## COMMISSION DIRECTIVE

of 15 December 1982

**adapting to technical progress Council Directive 79/622/EEC on the approximation of the laws of the Member States relating to the roll-over protection structures of wheeled agricultural or forestry tractors (static testing)**

(82/953/EEC)

Figure 2

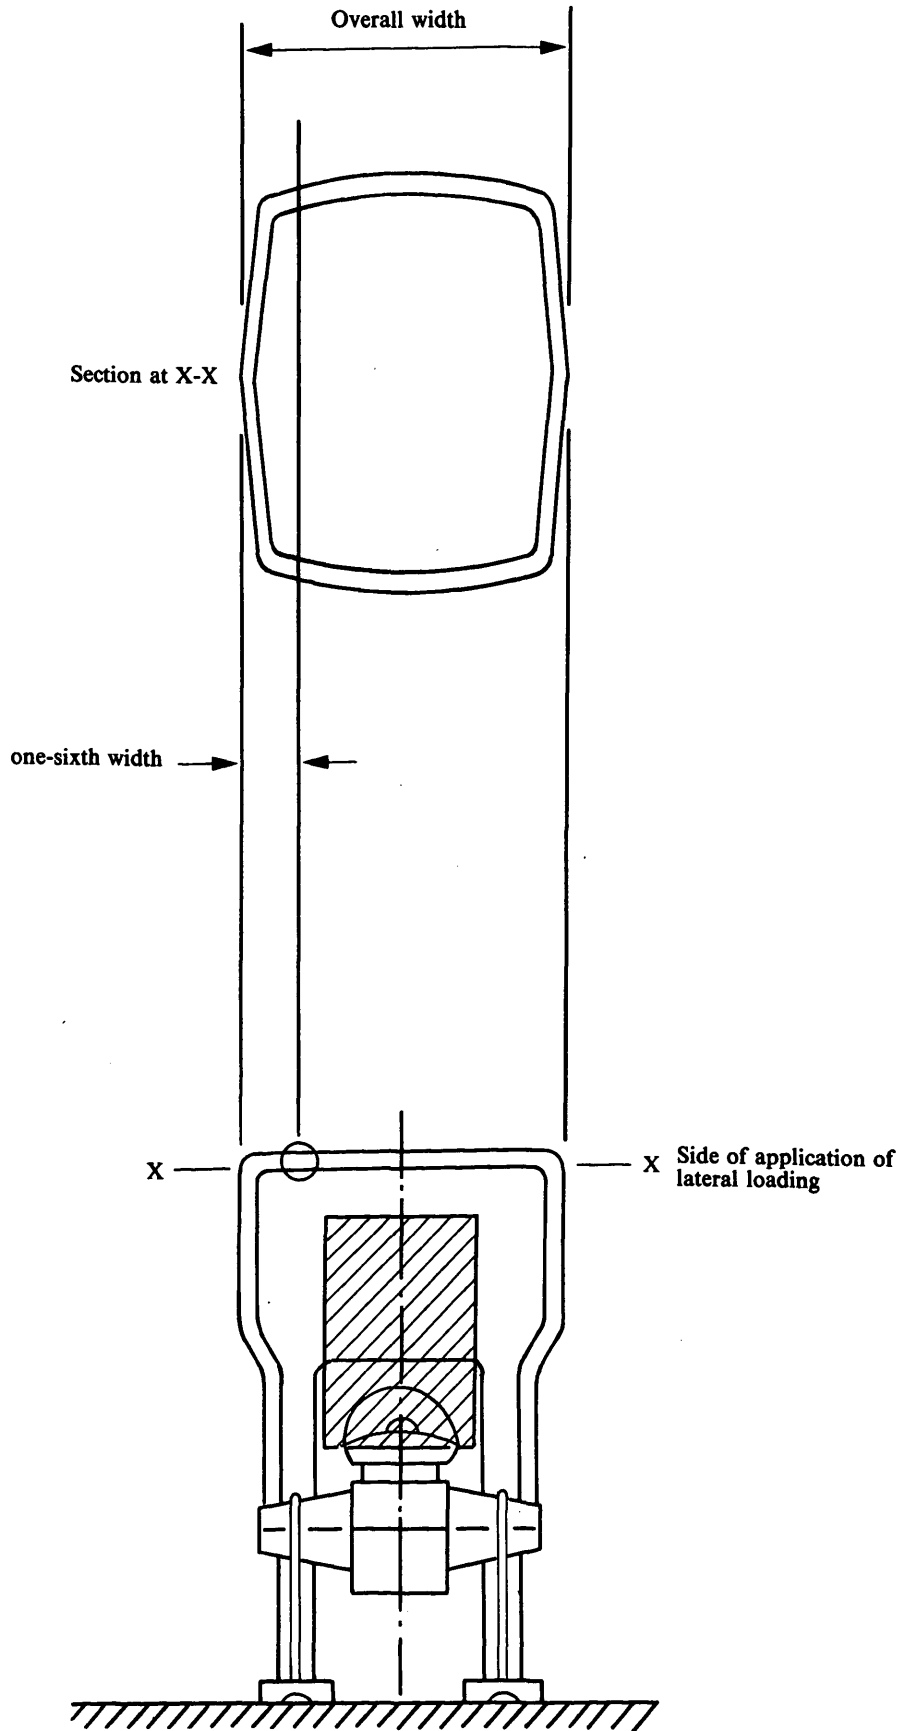
'1.2. Longitudinal loading (see Figure 2 of Annex IV)

Load application shall be horizontal and parallel to the vertical median plane of the tractor.

For tractors with at least 50 % of their mass, as defined in Item 1.3 of Annex II, on the rear wheels, the longitudinal rear load and the lateral load shall be applied on different sides of the median longitudinal plane of the protection structure. For tractors with at least 50 % of their mass on the front wheels, the longitudinal front load shall be on the same side of the median longitudinal plane of the protection structure as the lateral load.

It shall be applied to the uppermost transverse structural member of the protection structure (i.e. the part which would be likely to strike the ground first in an overturning incident).

The point of application of the load shall be located one-sixth of the width of the top of the protection structure inwards from the outside corner. The width of the protection structure shall be taken as the distance between two lines parallel to the vertical median plane of the tractor touching the outside extremities of the protection structure in the horizontal plane touching the top of the uppermost transverse structural members.

The length of the beam shall be not less than one-third of the width of the protection structure (as previously described) and not more than 49 mm greater than this minimum.

The diagrams in Figures 2, 4a, 4b and 4c, shall be replaced by the following :

Figure 4a

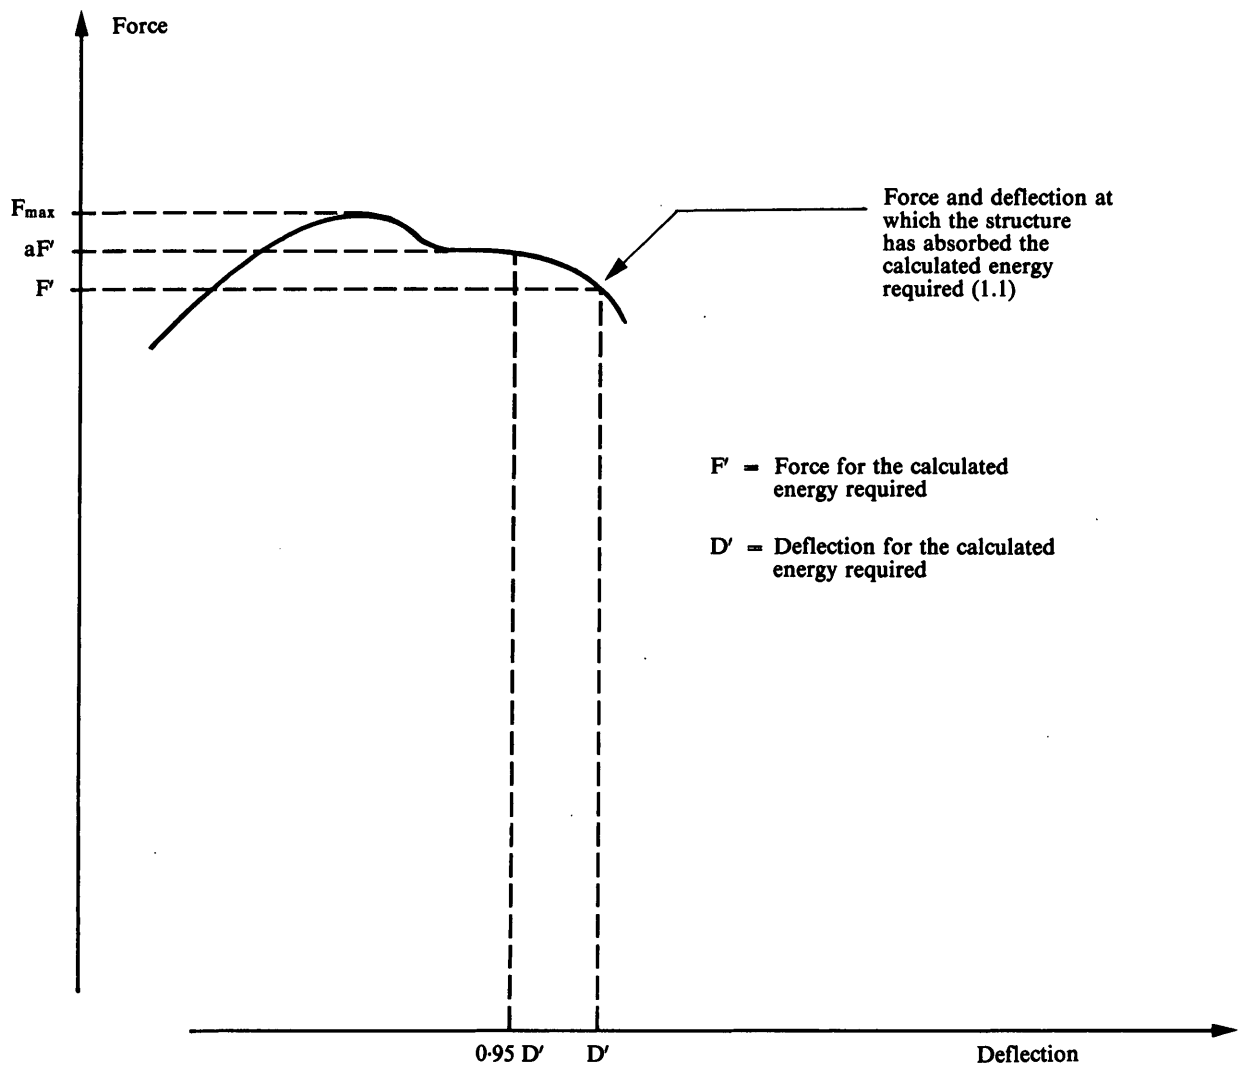
1. Point of reference  $aF' = 0.95 D'$ .

1.1. The overload test is not necessary since  $aF' < 1.03 F'$ .

*Figure 4b*

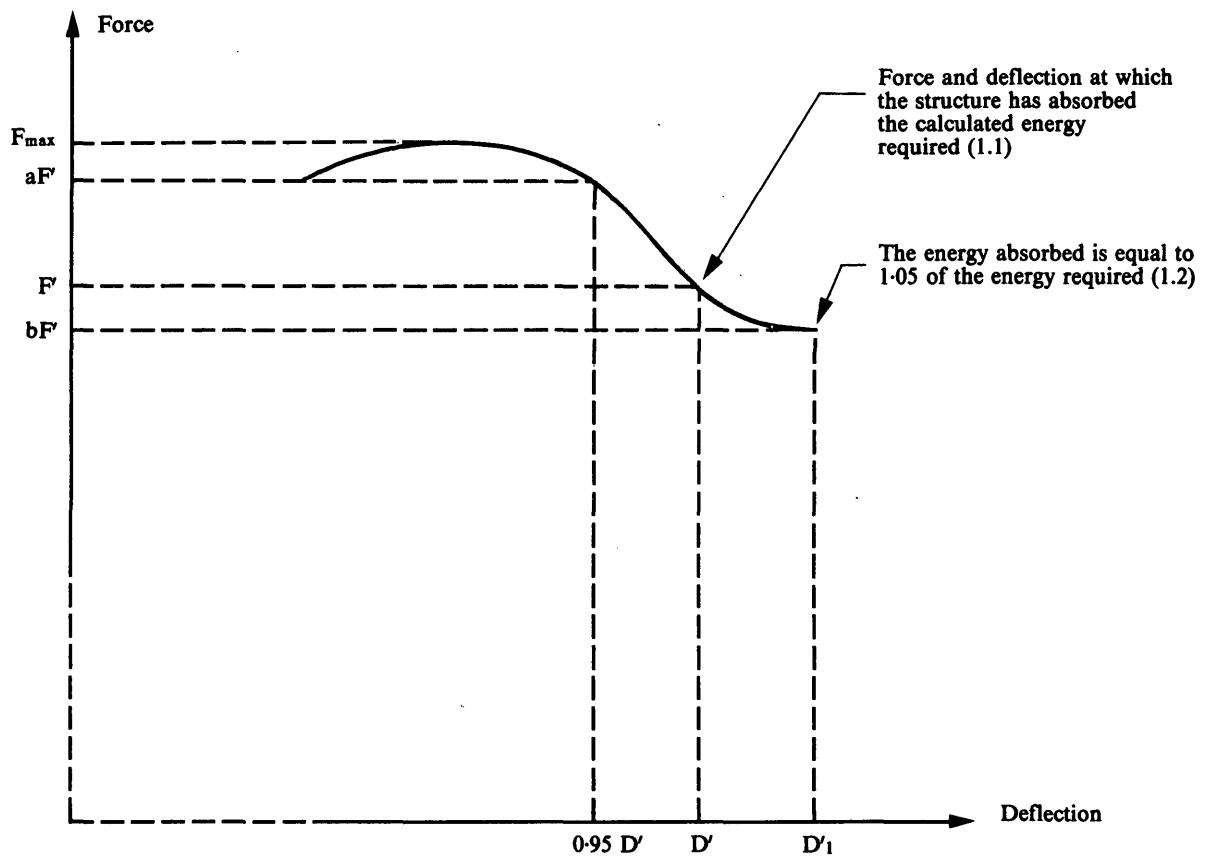
An overload test shall be carried out in all cases where the force decreases by more than 3 % during the last 5 % of the deflection reached when the energy required is absorbed by the structure (see figure 4b).

1. Reference point  $aF' = 0.95 D'$ .

1.1. The overload test is necessary since  $aF' > 1.03 F'$ .

1.2. The overload test is satisfactory since  $bF' > 0.97 F'$  and  $bF' > 0.8 F_{max}$ .

Figure 4c  
Force/deflection curve — overload test to be continued

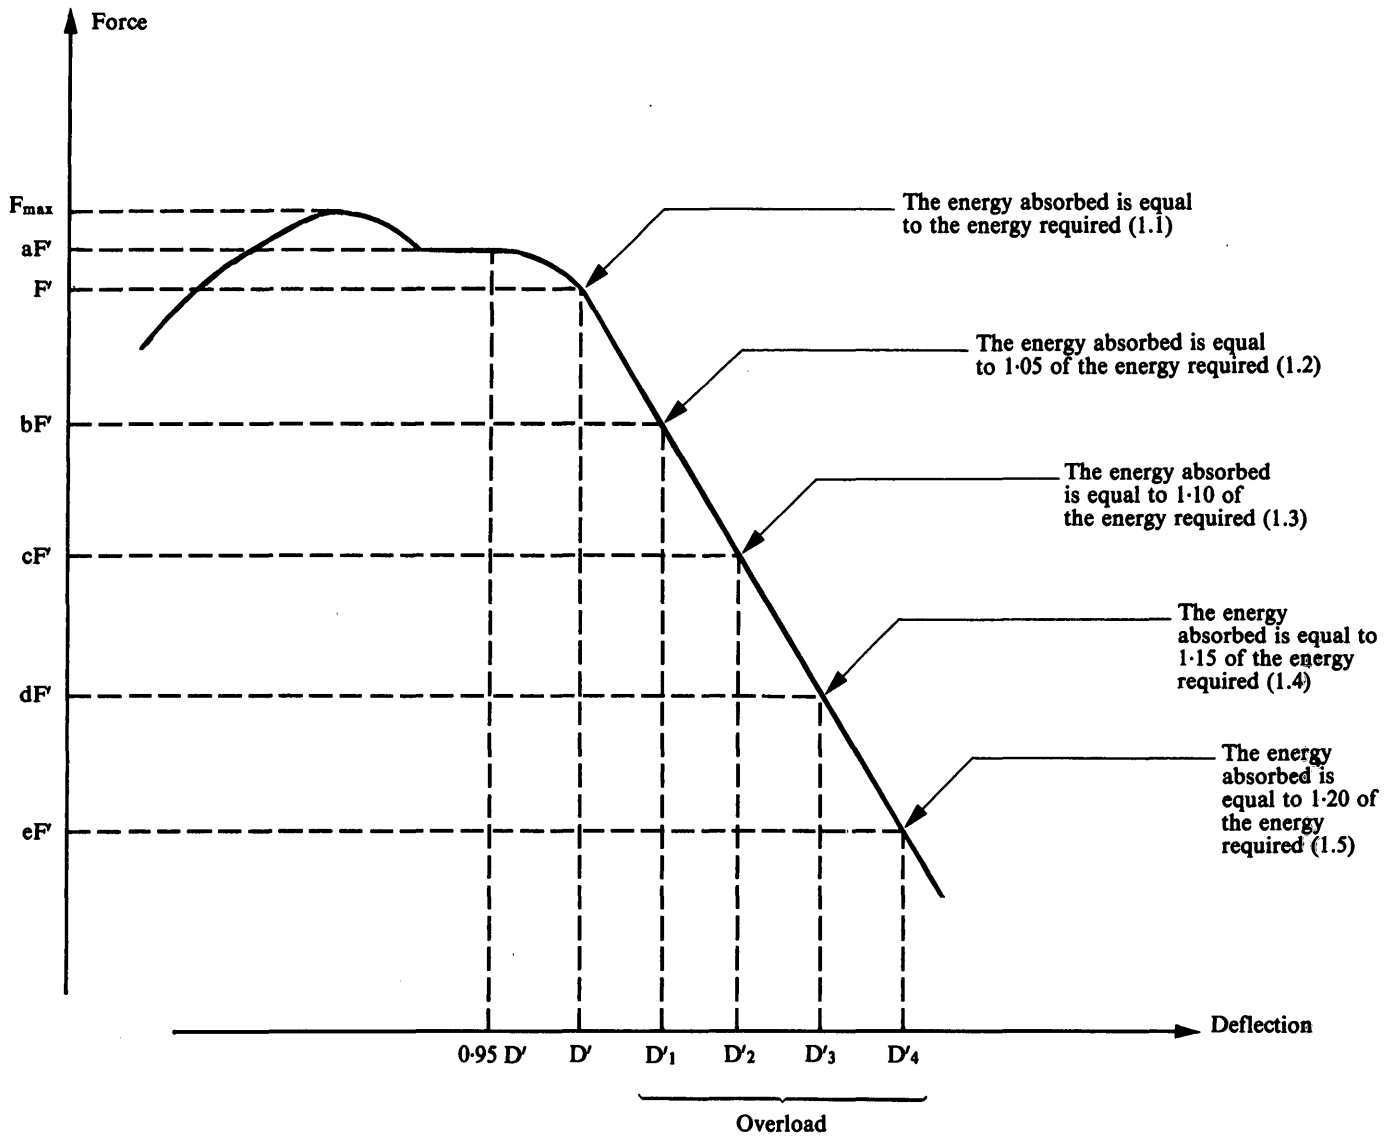
- 1.4.2. The overload test involves the gradual increase of the horizontal load by increments of 5 % of the initial energy requirement up to a maximum of 20 % of energy added (see figure 4c).

- 1.4.2.1. The overload test is satisfactory if, after each increase by 5, 10 or 15 % in the energy required, the force decreases by less than 3 % for a 5 % increment and remains more than 0.8  $F_{max}$ .

- 1.4.2.2. The overload test is satisfactory if, after the structure has absorbed 20 % of the added energy, the force exceeds 0.8  $F_{max}$ .

1. Reference point  $aF' = 0.95 D'$ .
- 1.1. The overload test is necessary since  $aF' > 1.03 F'$ .
- 1.2. Since  $bF' < 0.97 aF'$  the overload test must be continued.
- 1.3. Since  $cF' < 0.97 bF'$  the overload test must be continued.
- 1.4. Since  $dF' < 0.97 cF'$  the overload test must be continued.
- 1.5. The overload test is satisfactory since  $eF' > 0.8 F_{max}$ .

**NB:** If at any time  $F$  drops below  $0.8 F_{max}$ , the structure is rejected.
